May 7, 2012

DEPARTMENT OF
PUBLIC WORKS
BUREAU OF SANITATION

TECHNICAL COMMENTS ON THE PROPOSED AMENDMENT TO THE WATER QUALITY CONTROL PLAN FOR THE LOS ANGELES REGION TO REVISE TMDLS FOR BACTERIA FOR (1) SANTA MONICA BAY BEACHES, (2) MARINA DEL REY HARBOR, MOTHERS' BEACH, AND BACK BASINS, AND (3) LOS ANGELES HARBOR, INNER CABRILLO BEACH, AND MAIN SHIP CHANNEL

Figure 1. Marina del Rey Subwatersheds, Back Basins, and Jurisdictions

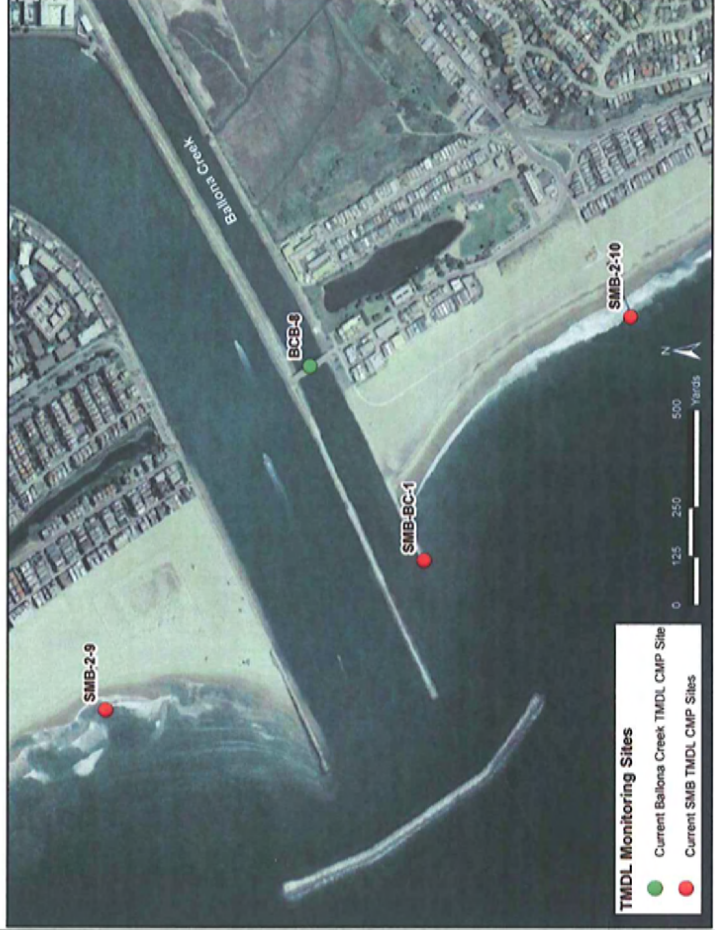
Major Mdr Comment #1) *The City of Los Angeles is jointly responsible for attainment of WLAs in Basins E and G. Attainment of WLAs in Basins A, C, D, F, and H should not be linked the City of Los Angeles' compliance determination.*

To date, the Regional Board has held the City accountable for attainment of WLAs at all compliance monitoring locations in Marina del Rey. However, urban runoff from the City only drains to Back Basins E and G. As shown in **Figure 1**, the City's jurisdiction drains Mdr subwatershed areas 1A, 2, 3, and 4. However, as shown in **Table 3**, these subwatersheds drain to Basins E and G. As such, the City's compliance with the Mdr TMDL should not be linked to attainment of WLAs in Basins A, C, D, F, or H. Note that Basin G currently attains WQOs and thus is not listed as impaired.

Previous dry weather circulation and modeling studies have demonstrated that Basin E is not hydraulically connected to Basin D, which indicates it is not connected to other basins, either. These findings are from a report developed by the County of Los Angeles Department of Beach and Harbors using Proposition 13 funds². The study included development of two hydrodynamic models, one that was bacteria-specific. The model results demonstrated that exceedances in Basin E are limited in spatial influence during non-storm conditions.

REQUEST: Clarify in the BPA for the Mdr Bacteria TMDL that the City is a responsible jurisdiction for Back Basins E and G only. The City's compliance with the Mdr TMDL should not be linked to attainment of WLAs in Basins A, C, D, F, or H. Note that the allocations for Inner Cabrillo Beach are an example of WLAs for specific sites being assigned to specific agencies.
